# UNITED STATES PATENT AND TRADEMARK OFFICE

<b>Office Action Summary</b>	<b>Application No.</b>	<b>Applicant(s)</b>	
	10/648,387	CATER, MIRO S.	
	<b>Examiner</b>	<b>Art Unit</b>	
	Frederick C. Nicolas	3754

**DETAILED ACTION**

Fig. 1

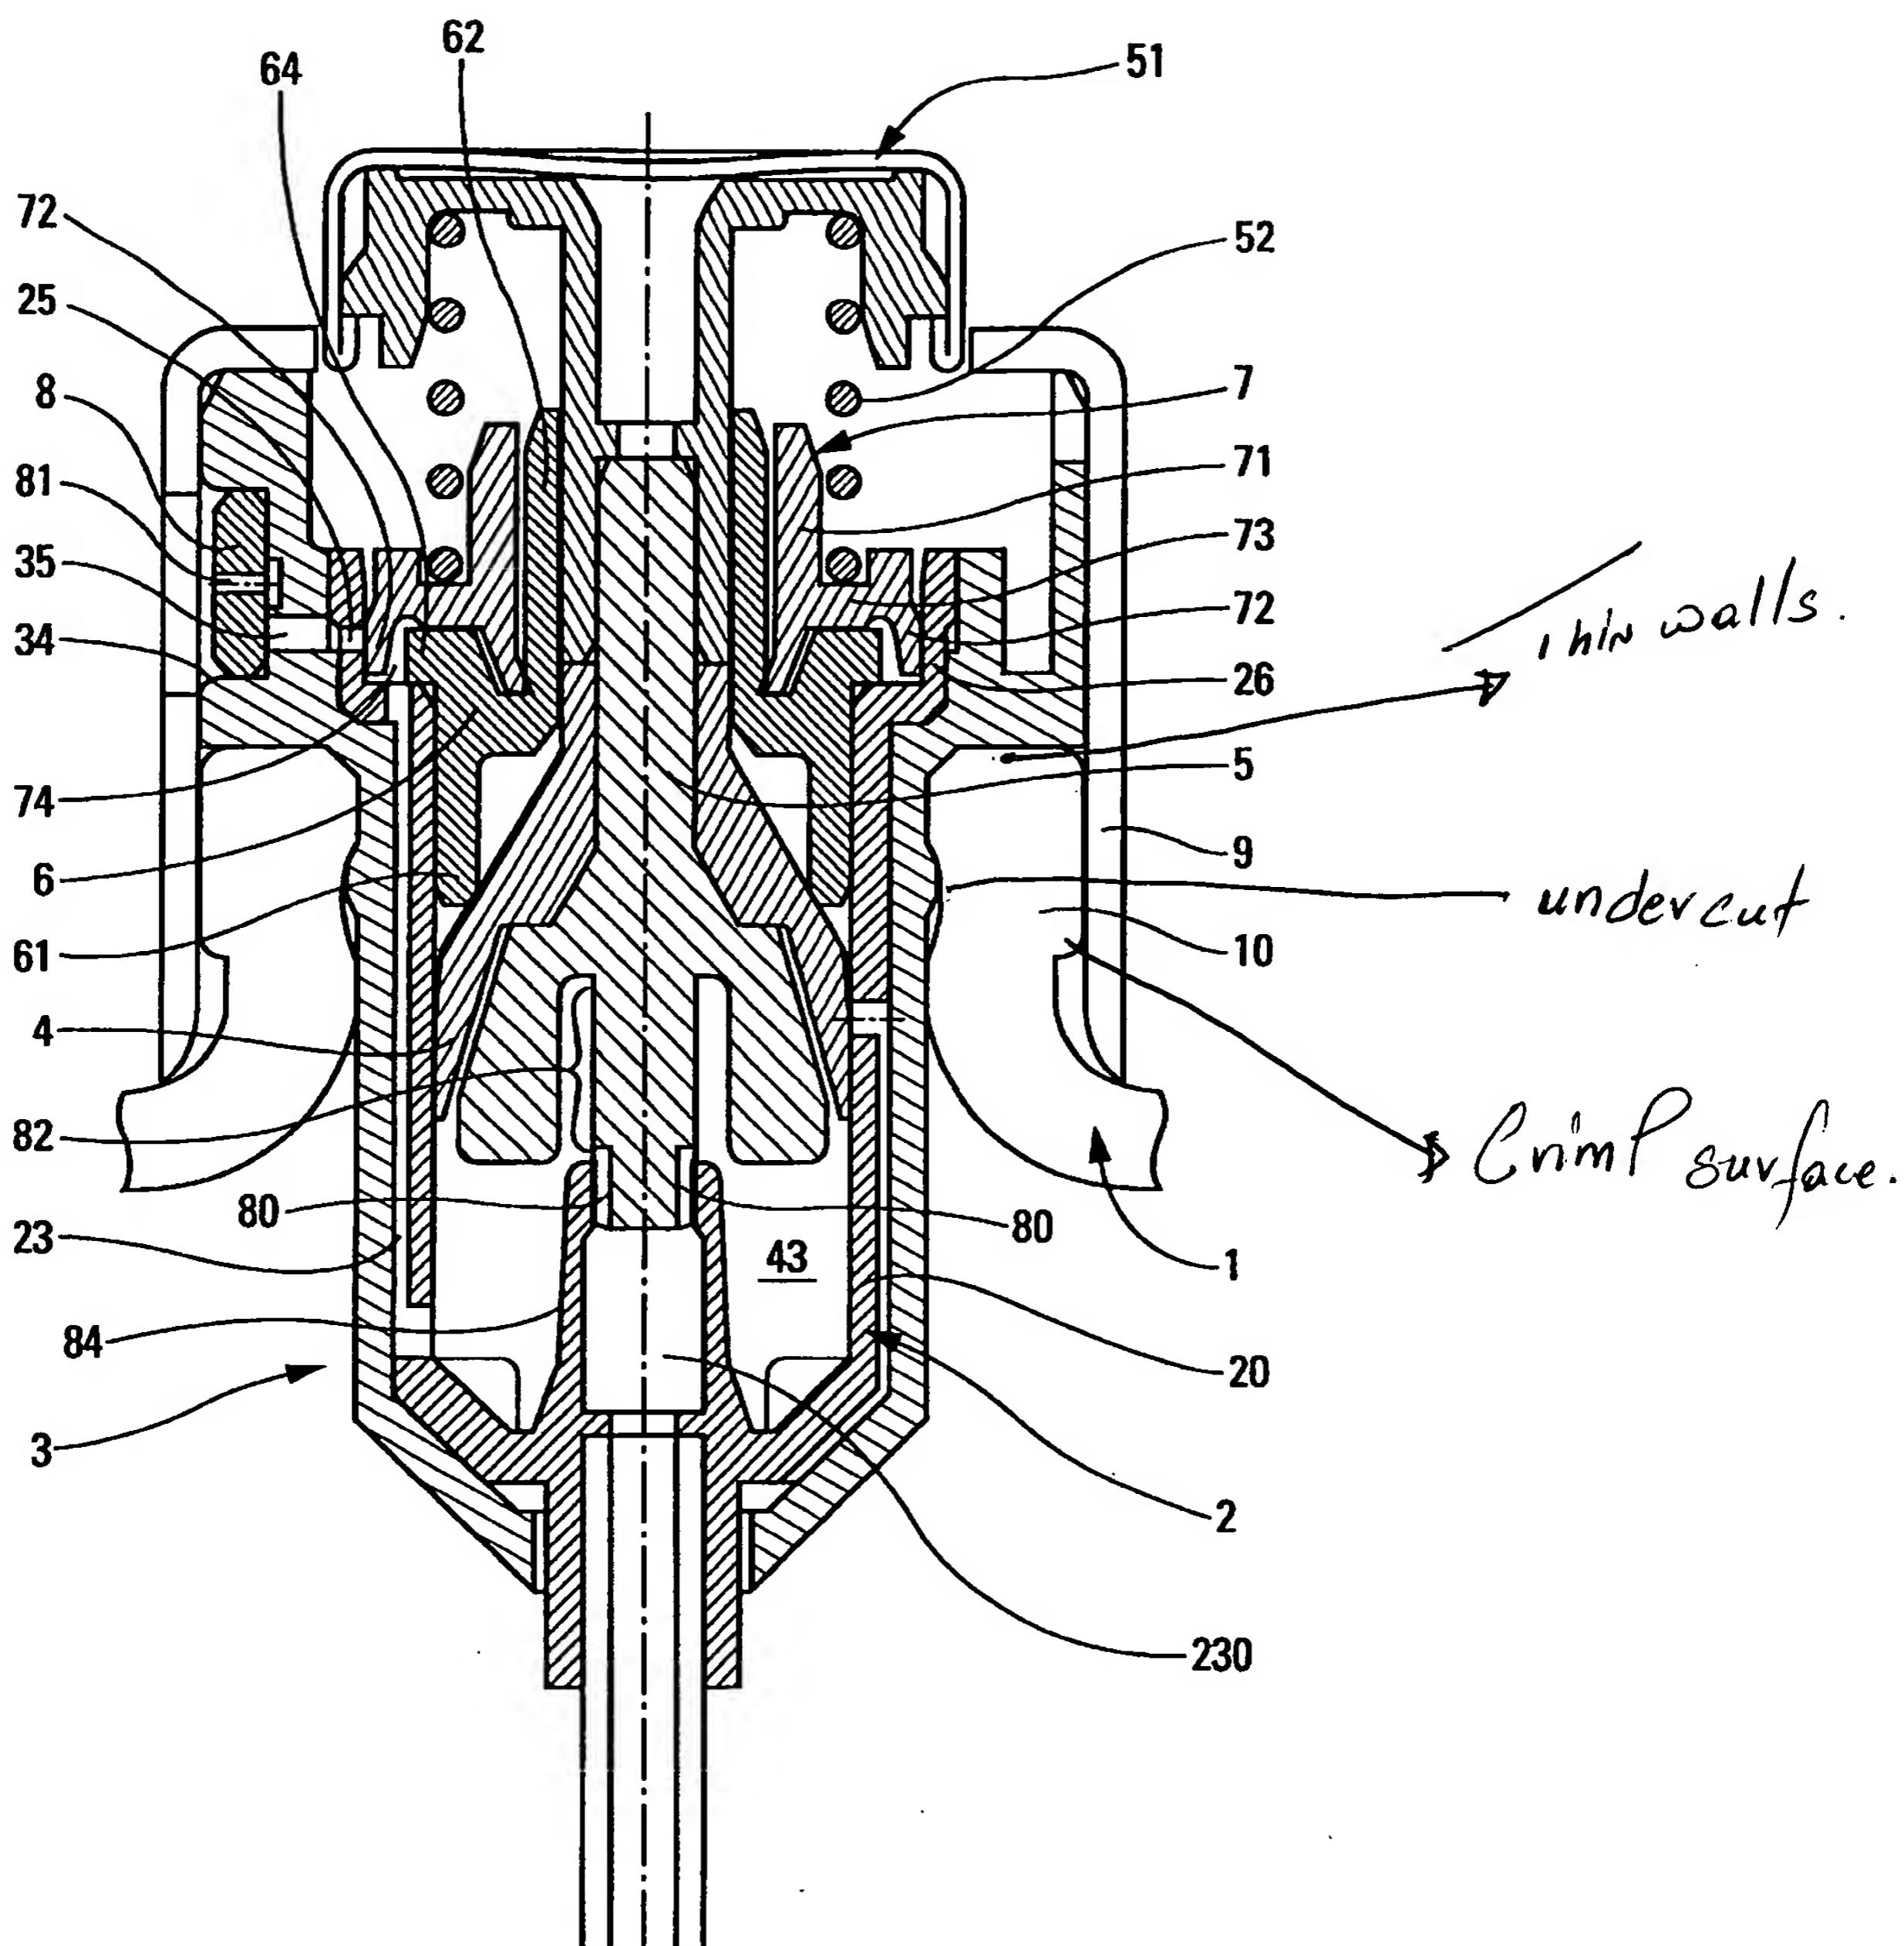
8. Claim 14 is rejected under 35 U.S.C. 102(e) as being anticipated by Garcia et al. 6,371,337.

Garcia et al. disclose a bottle (1), which comprises a body as seen in Figure 1, thin walls being formed around the opening (see Figure 1 for location of the thin walls, a thick section (10) spaced below the opening and forming an undercut (see Figure 1 for the location of the undercut), and a crimp surface formed on the outside of the neck (see Figure 1 for the location of the crimp surface).
